January 25, 2022

Assessment Ride Report - Stanley Park Protected Cycling Lanes

Figure 1 - Stanley Park Drive Assessment Ride route and stops

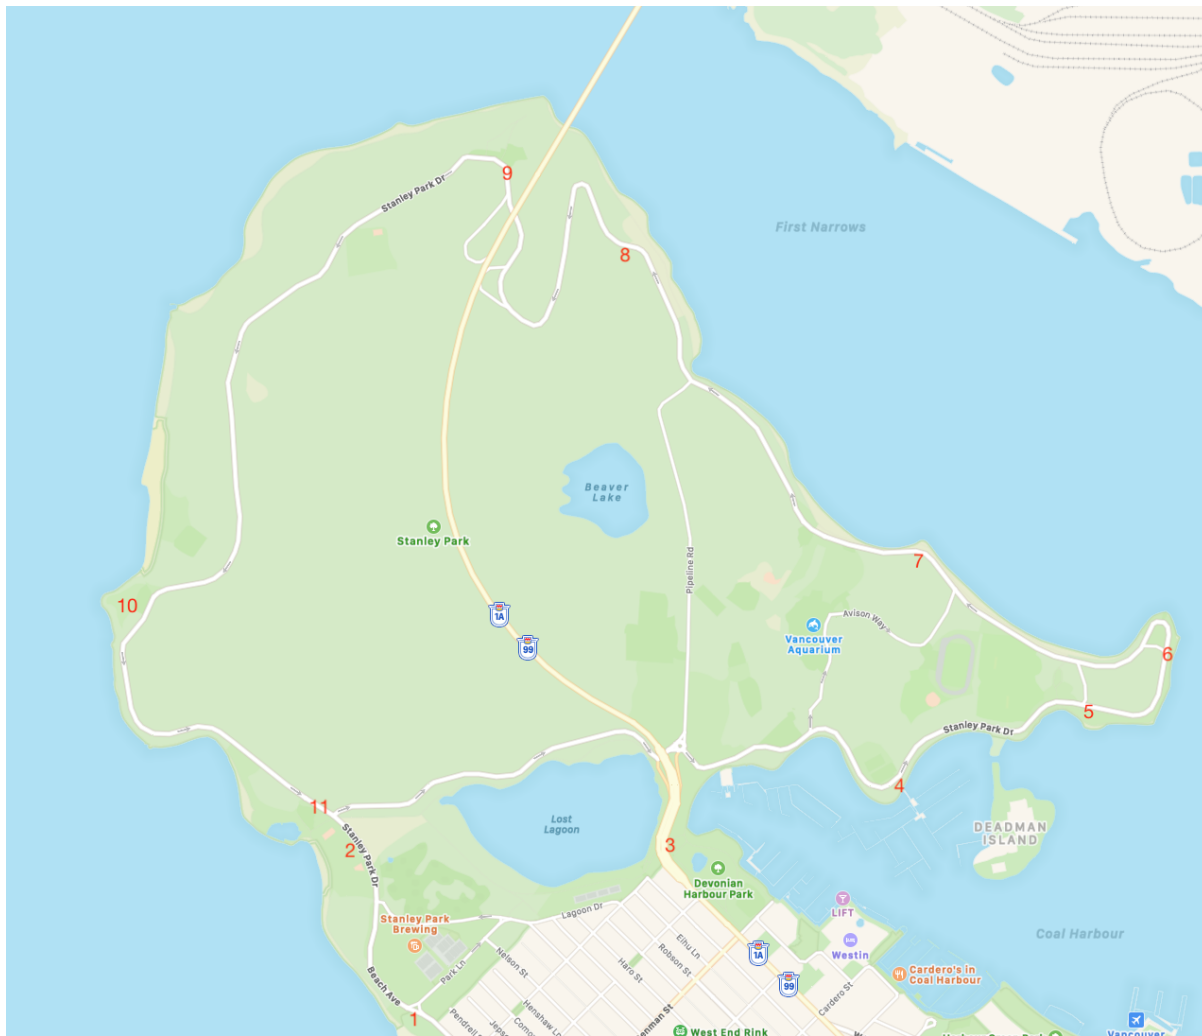
The implementation of the temporary protected cycling lanes has been a tremendous benefit for people cycling in Stanley Park. The Vancouver UBC Local Committee of HUB Cycling completed an assessment ride of the 2021 temporary lanes implemented in Stanley Park, in October 2021. The following recommendations are intended to inform the discussion around permanent traffic calming measures to be proposed by staff in early 2022. The assessment ride followed the route indicated in Figure 1, with stops indicated from labels 1 to 11.

Figure 28 - Bike and vehicle lanes approaching Prospect Point

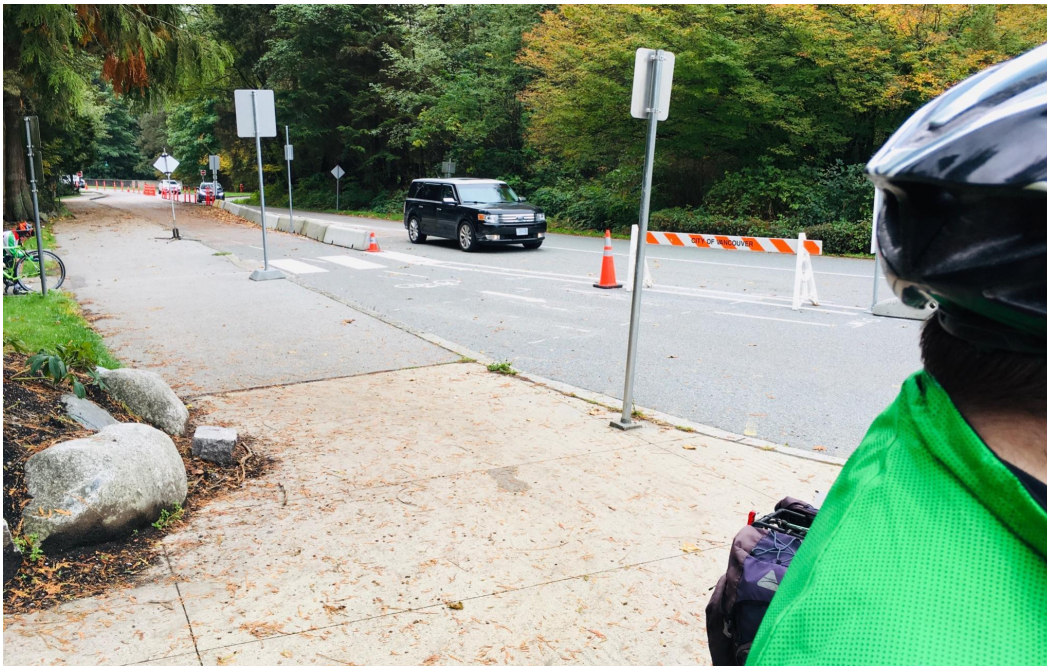
The entrance to Prospect Point, shown in Figures 27 and 28 on the following page, can be very confusing for people driving, and this can make it dangerous for people cycling. The markings are poor in terms of traffic flow lanes. Vehicle operators were observed stopping in the right turn lane, unsure of how to proceed. While the general layout can work, the temporary nature of the implementation appears to be a source of the confusion. Raised pedestrian crosswalks would help slow traffic here, as well as elsewhere in the park.
